## **REMARKS**

Responsive to the office action in the above referenced matter, sent on May 23, 2003, please see in the specification lines 93 and 94, which specifically set forth that a power drive motor is typically incorporated into and enclosed, by ratchet handle

Fig. 1

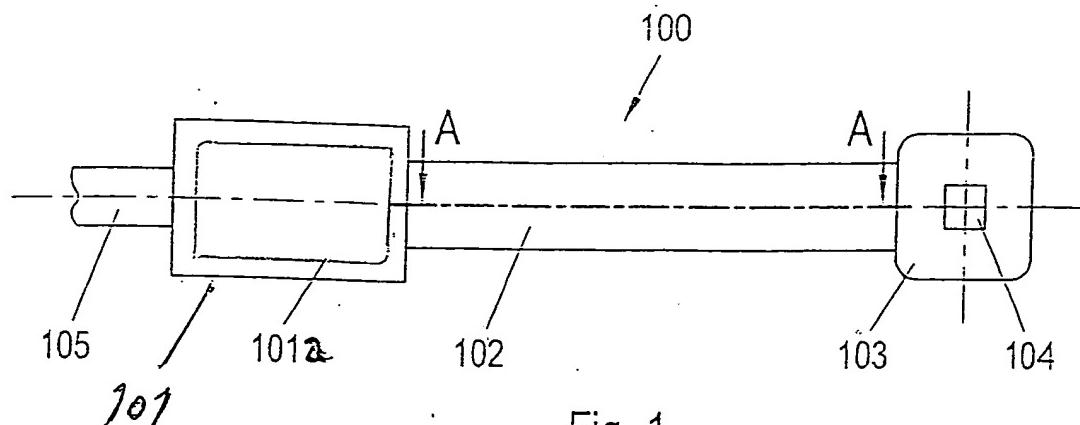
1. The drawings are objected to under 37 CFR 1.83(a). The drawings must show every feature of the invention specified in the claims. Therefore, the motor contained in the handle must be shown or the feature(s) canceled from the claim(s). No new matter should be entered. A proposed drawing correction or corrected drawings are required in reply to the Office action to avoid abandonment of the application. The objection to the drawings will not be held in abeyance, 2. Figure 3 should be designated by a legend such as --Prior Art-- because only that which is old is illustrated, per Applicant's disclosure, lines 135 and 136. See MPEP § 608.02(g). A proposed drawing correction or corrected drawings are required in reply to the Office action to avoid abandonment of the application. The objection to the drawings will not be held in abeyance.

101 To comply with the examiner's request, we have the following change in the specification, as requested. In line 94, after a power drive motor, insert 101 (a) and delete the article (a) preceding power drive motor. Please see the attached proposed revised drawings; to Figures 1, 2, 4(a), and 4(b) which illustrate power drive motor 101 (a) inside ratchet handle 101.

Fig. 3

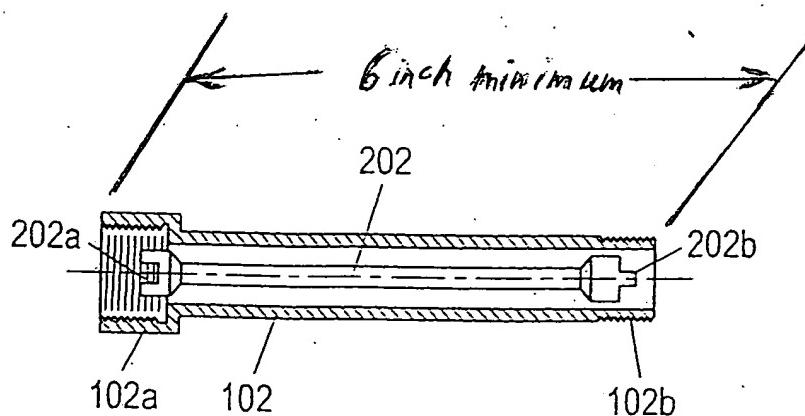
10. Claims 1, 3, 7. 9 and 11 (as best understood) are rejected under 35 U.S.C. 102(b) as being anticipated by Applicant's Admitted Prior Art (AAPA). As admitted by Applicant, lines 135 and 136, a power ratchet wrench as shown in Fig. 3 is old, thus meeting the claims limitations as explained above.

With respect to the rejection in paragraph 10 of the foregoing claims pursuant to 35 USC 102(b), as being anticipated by the applicant's admitted prior art, it is respectfully suggested that all of the prior art show close coupling between a ratchet handle and head providing for a "compact" power-assisted ratchet, essentially consistent with the teachings in Lampke cited above. None of the prior art, in spite of the existence of these types of power-assisted lever arm ratchets for periods in excess of 50 years teach or suggest that an improvement, which is the subject of this present
